Better Apartments Draft Design Standards

Industry Submission – September 2016

Urban Development Institute of Australia (Victoria)

20 STOREY TOTAL DEVELOPMENT

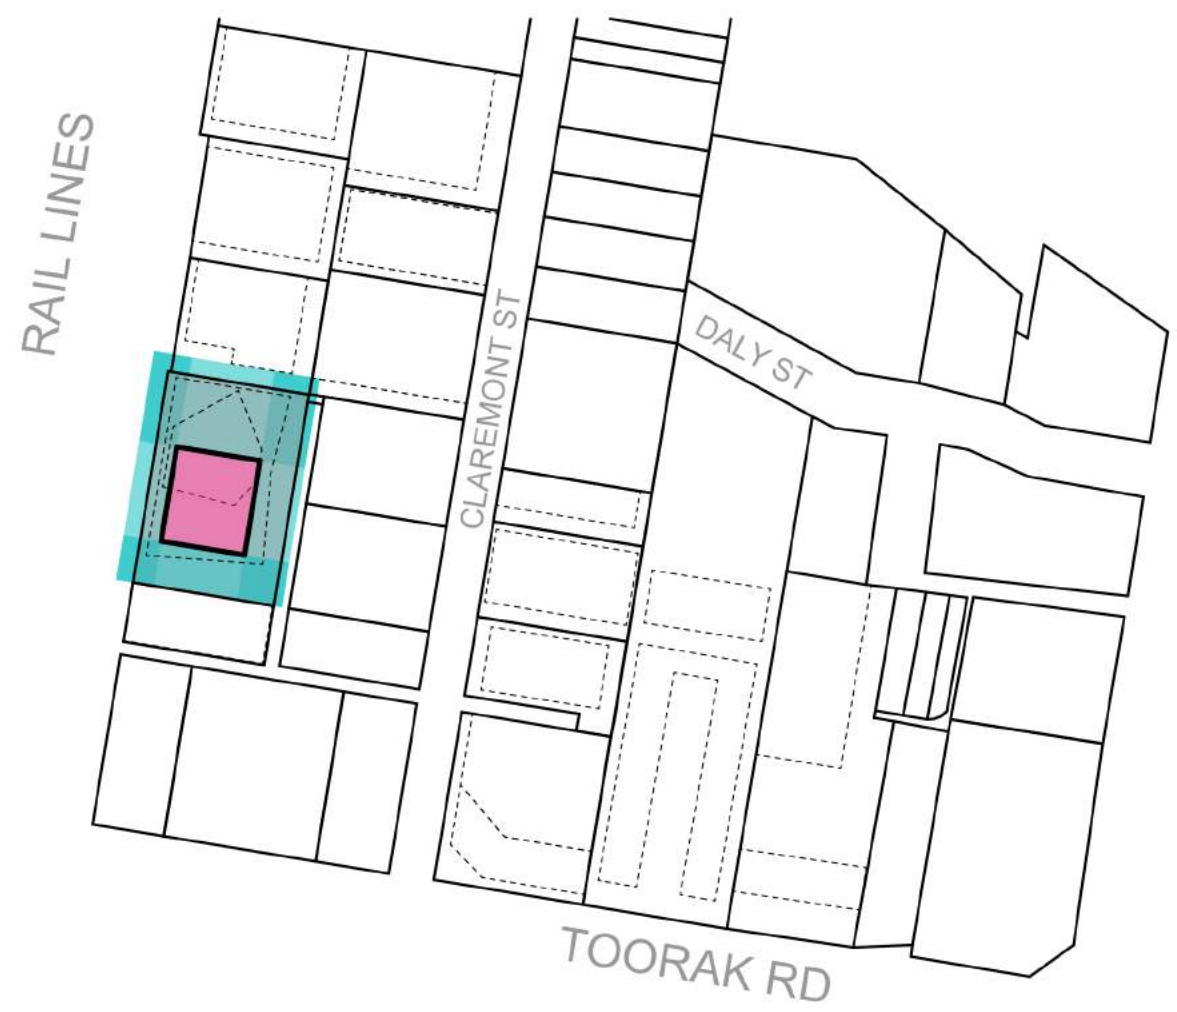
Further investigations into the potential yield to calculate an estimated cost for each site when they must be amalgamated for any development to be possible. The individual site value in this case is lower than the current assets built on the sites and therefore would not be suitable for development. The yield of the two sites is now 228 apartments. Under the old planning rules, it was 250 apartments on each site: 2 x 250 = 500 apartments. The loss of apartments on just two sites is 272 apartments.

SITE VALUE AS A RESIDENTIAL DEVELOPMENT: \$22.8M
MARKET VALUE OF EXISTING OFFICE BUILDINGS \$32.0M

DEVELOPMENT NOT VIABLE

CENTRAL SOUTH YARRA AS BUILT: 357 APT

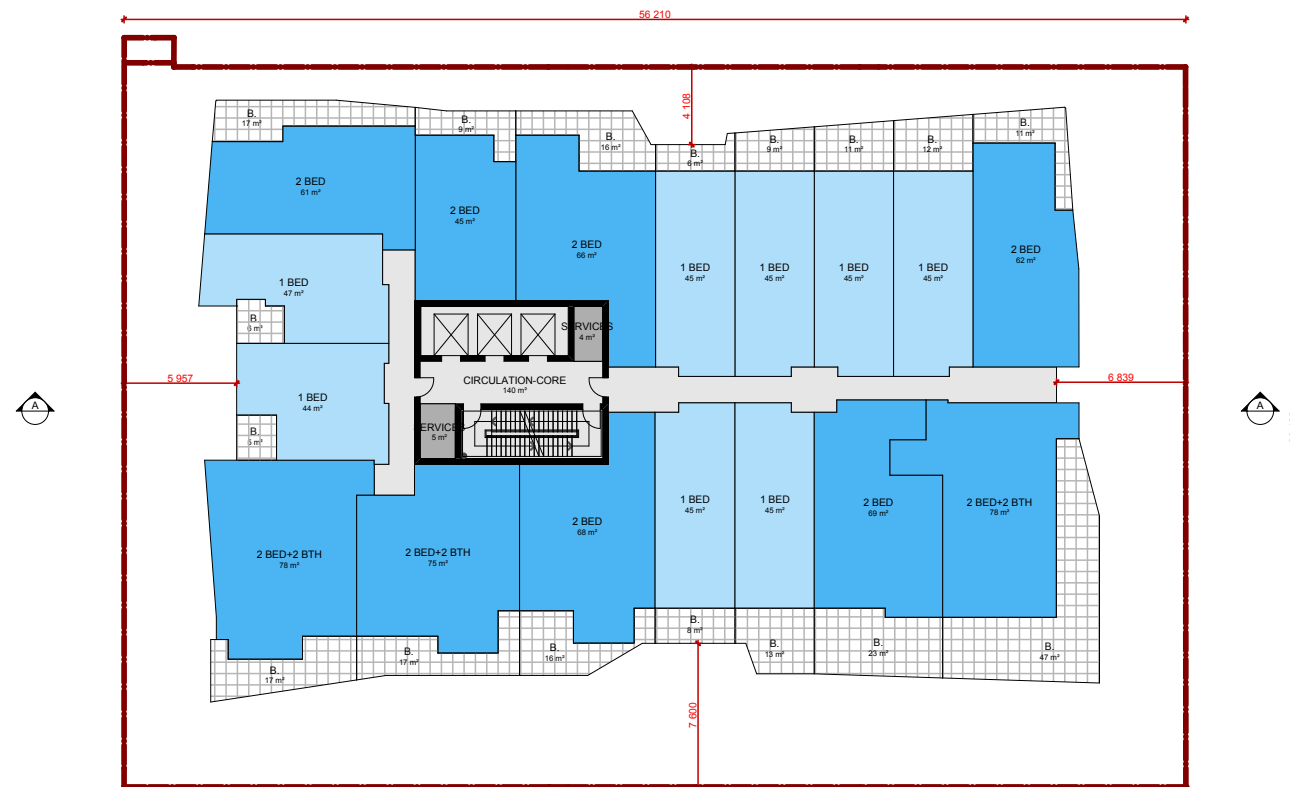
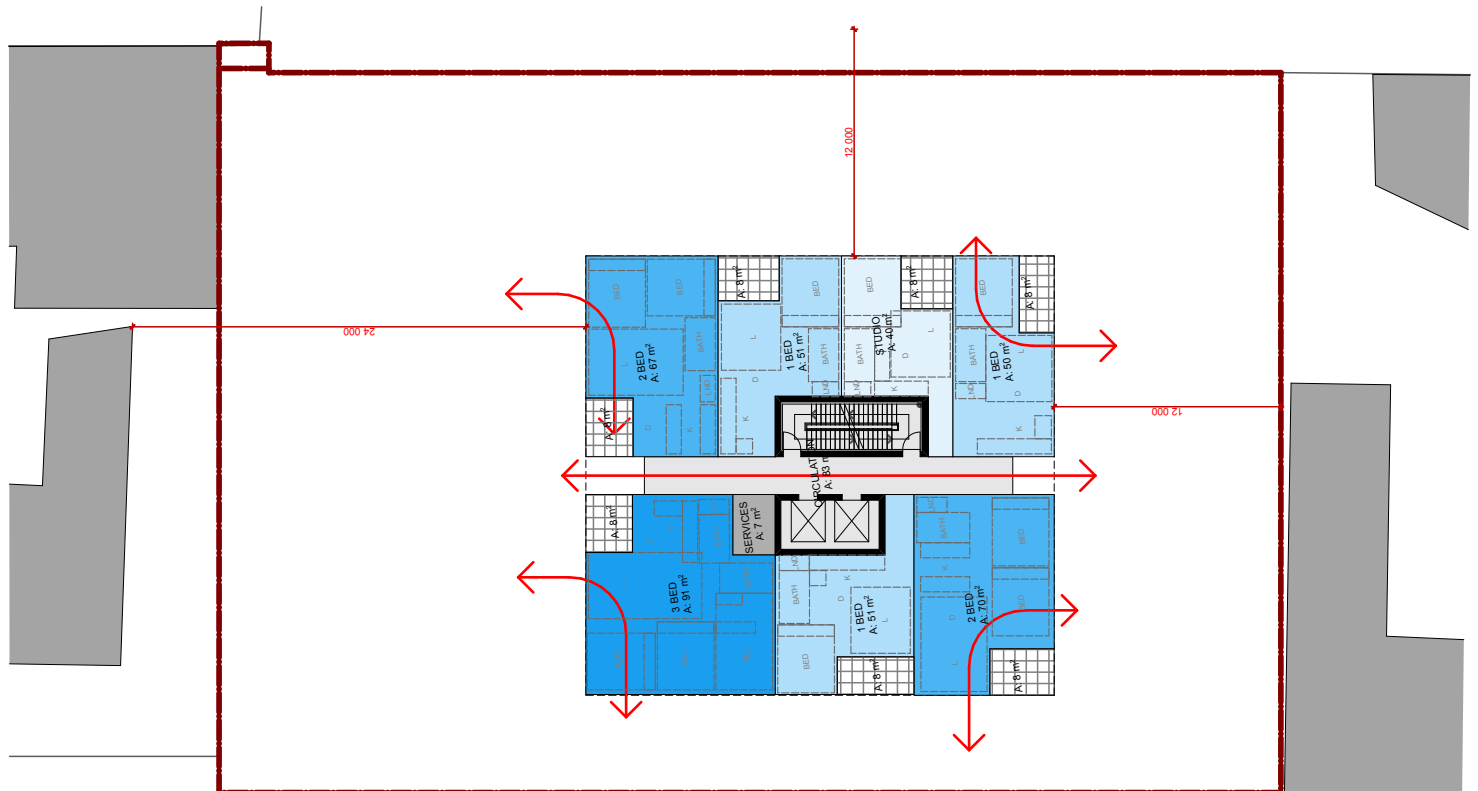
Further investigations into the potential yield to calculate an estimated cost for the site and total number of apartments. This can be compared against the actual yield delivered of a residential development of this site that was completed in 2015. The yield of the sites is now 167 apartments. Under the old planning rules, 357 apartments were built. The loss of apartments on just one site is 190 apartments.

167 APT x \$100k = \$16.7M
SITE VALUE = \$16.7M

CENTRAL SOUTH YARRA NEW PROPOSAL: 167 APT

CASE STUDY ENDORSED 350 QUEEN STREET:

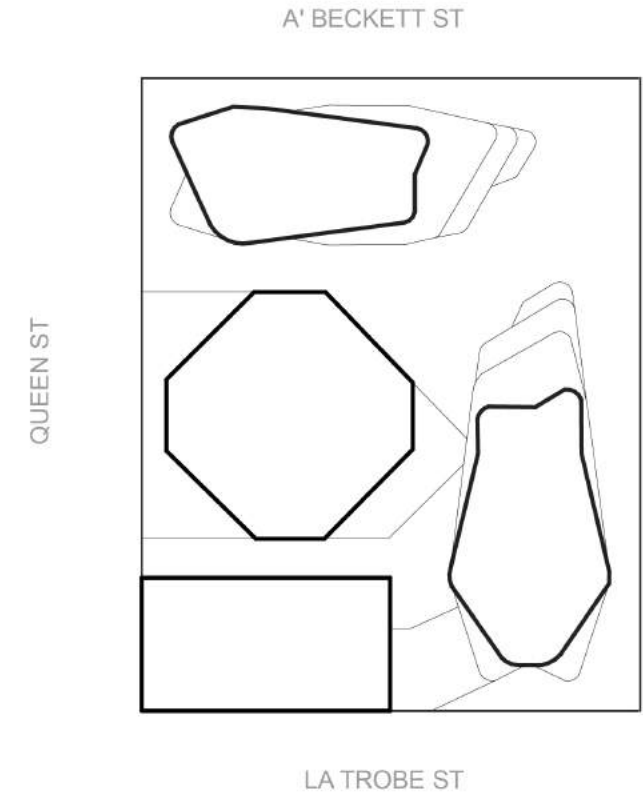
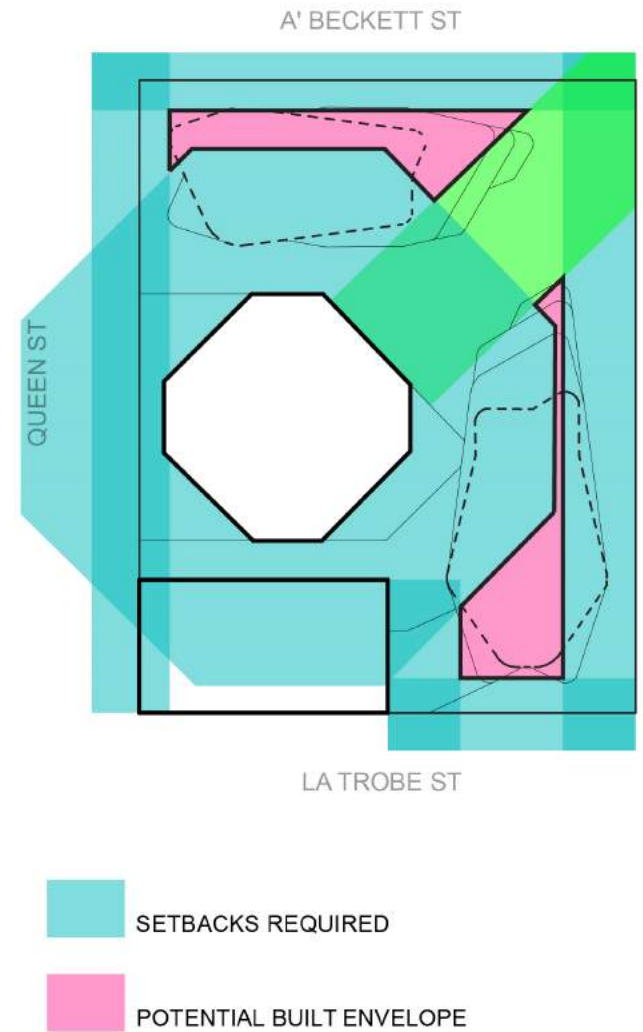
We have produced a detailed feasibility study of a typical floor plate for a multi storey residential tower after applying all the aforementioned proposed measures. This can be concisely compared with a feasibility study applying the SEPP 65 measures and also with the recently completed 30 storey apartment towers as built drawings.

The endorsed, highly commendable development, no longer has any potential yield as the setbacks from the multi-level commercial building on the site to remain, completely envelope the available site area. Side boundary site setbacks further reduce available area and finally separation between the towers of 24.0m mean the development would no longer proceed.
